**Trans Mountain Pipeline ULC
Trans Mountain Expansion Project
NEB Hearing Order OH-001-2014
Responses to Information Request from
Robyn Allan**

1.01 Trans Mountain and the Public Interest

Figure 1.1cc-1 Pipeline Incidents: Spills of Hydrocarbon Liquids

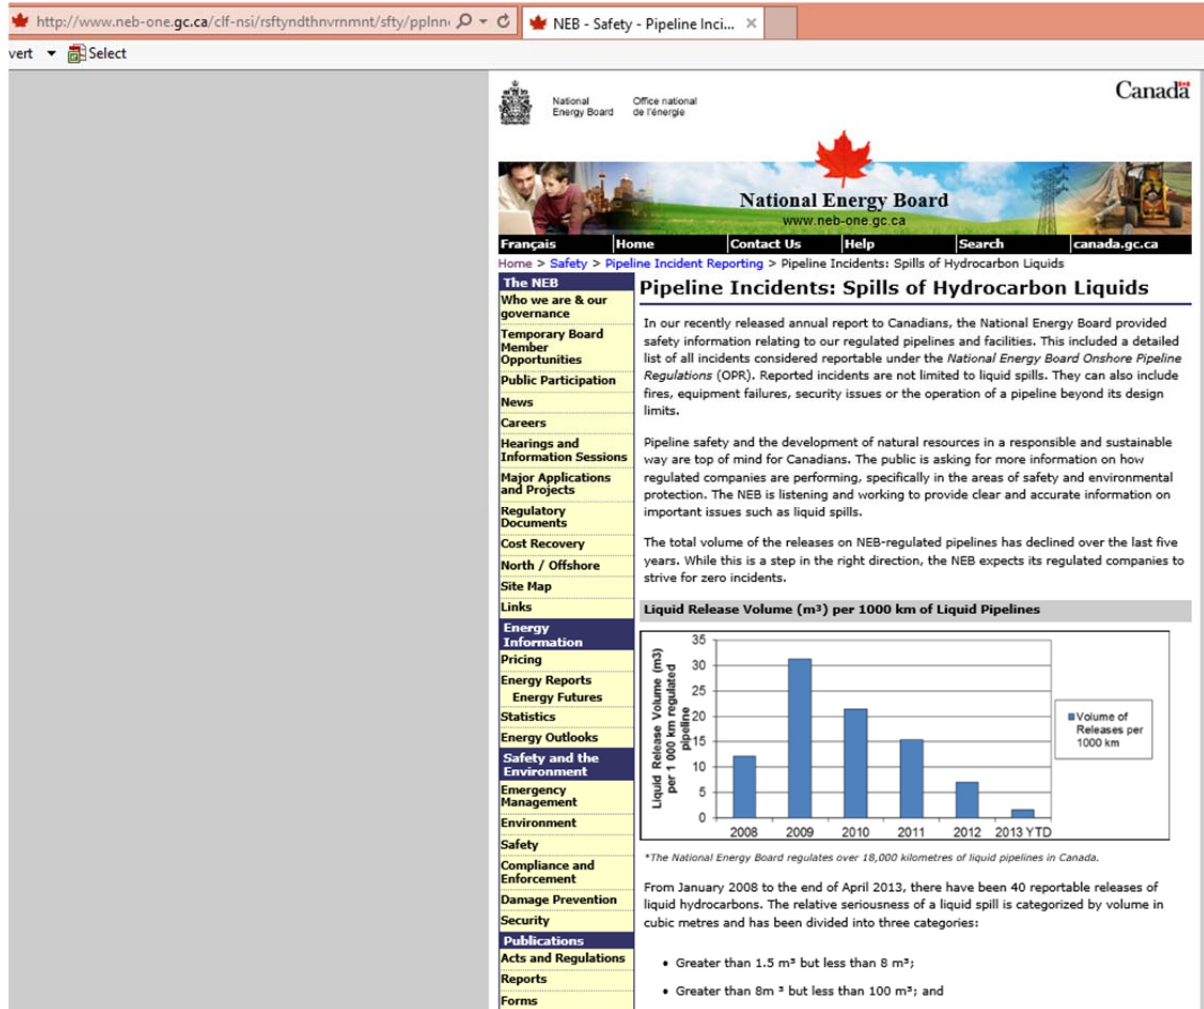
- dd) Please confirm that when reference (ix) states, "The net overall effect (of a pipeline spill) depends on the size and extent of a spill, the associated demand for clean-up services and personnel, the capacity of local and regional businesses to meet this demand, the willingness of local businesses and residents to pursue response opportunities, the extent of business and livelihoods adversely affected (directly or indirectly) by the spill, and the duration and extent of spill response and clean-up activities" that this statement means it is possible for the economic benefits of a pipeline spill to exceed its economic costs. If unable to confirm please provide an explanation for what is meant by the "net overall effect."

The reference to a positive net overall effect refers solely to financial considerations, an example being a small spill to land, where the extent of the spill is limited by the volume of the release and spill response actions, and where clean-up, remediation costs paid to a contractor exceed the value of the spilled product and any losses to the landowner or user. This economic outcome obviously does not factor in other social or environmental effects mentioned elsewhere in Section 6, Volume 7 and would not be true for a large spill that is understandably the focus of most intervenors. Spills are not part of the

Concerns about spills were frequently raised during consultation for the Project, and the risk-based spill assessment submitted by Trans Mountain in the Facilities Application is systematic and thorough. This information confirms that, although the probability of a credible worst case crude oil spill is low, substantial negative effects can occur if prompt and effective measures are not taken to mitigate the immediate impacts by containment and recovery. This confirms that spill prevention, preparedness, and effective response activities must always be a primary focus to reduce the probability of an oil spill, and to have adequate oil spill response plans and procedures in place that have proven capability to reduce the magnitude and extent of actual effects on people and the environment.
